# Access Compliance Report

## Public Rights-of-Way

### (Curb Ramps)

Intersection ID: 10041617	Main Street: WHITEBURN_CT	Cross Street: N/A	Location: SE
ADA ID: 3CE67D45A388	Ramp Type: Perp	Initial Pass/Fail: Fail	Overall Compliance: No
Severity Score: 12.5			
Codes/Mitigation Info/Possible Solution		Field Measurements/Component Compliance

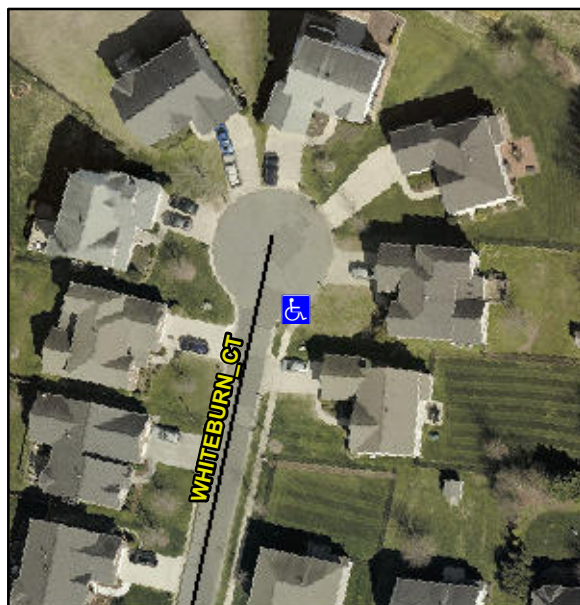
**Remove & Replace Entire Ramp.**

**Not Found, R304.2.2**
